ROOF PLACEMENT PLAN

ROOF AREA: 2767.84 sqft	RIDGE LINE: 75.27 ft	VALLEY LINES: 80.88 ft	HIP LINES: 64.59 ft	THESE VALUES ARE APPROXIMATE ONLY																												
GUILFORD FC RF A CAFE		PBS-NEW HOMES

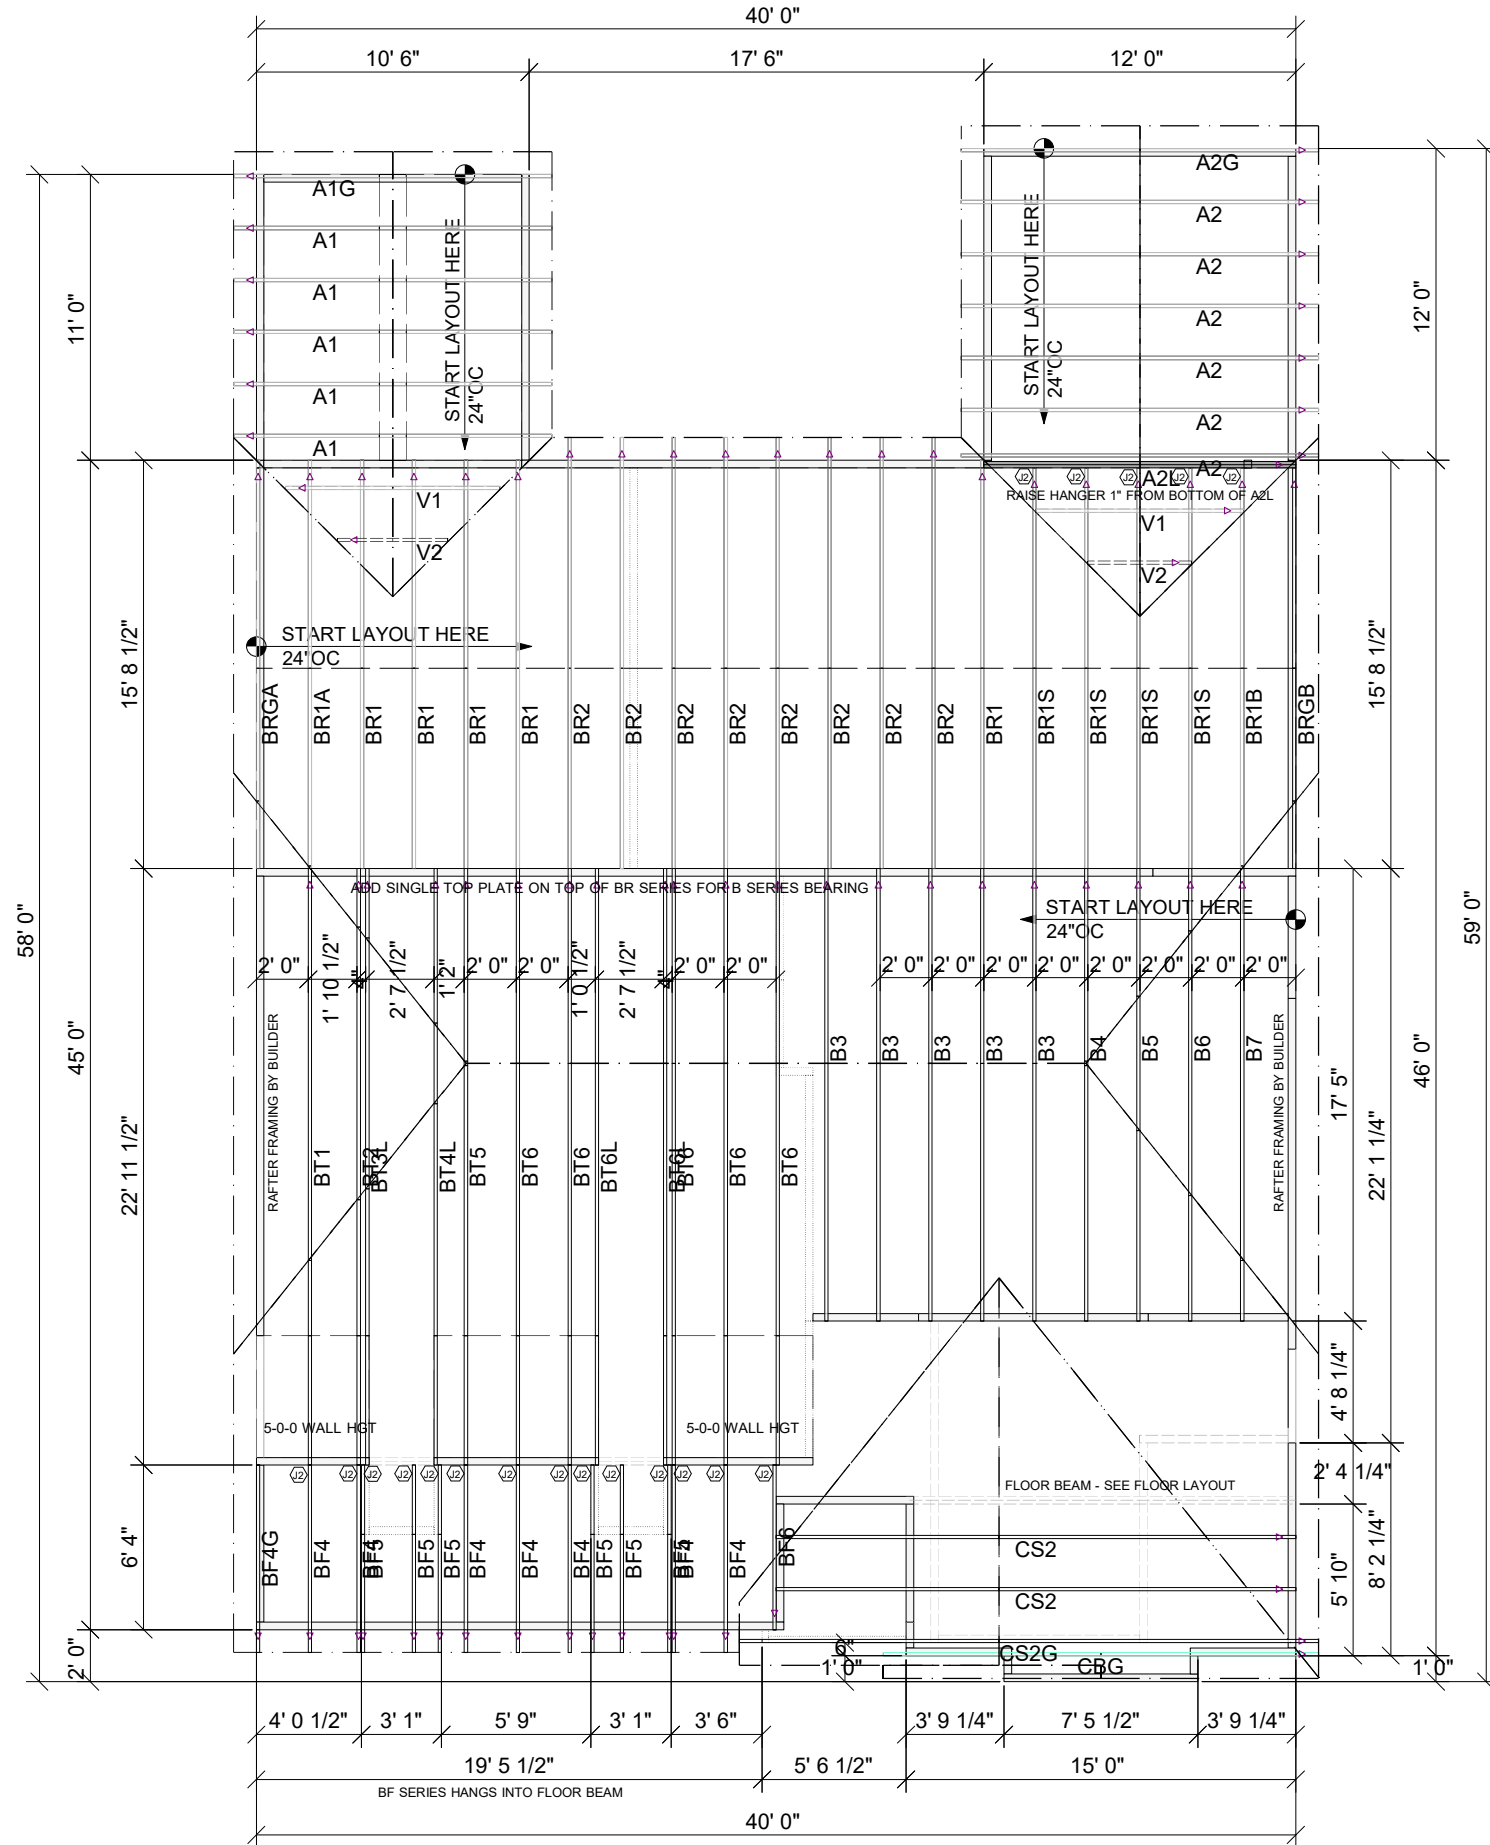
<table><tr> <th colspan="2">REVISIONS</th> <th>DSN</th> <th>AG</th> </tr><tr> <td>8-2-24</td> <td>ADD 2X4 GIRDER</td> <td></td> <td></td> </tr></table>
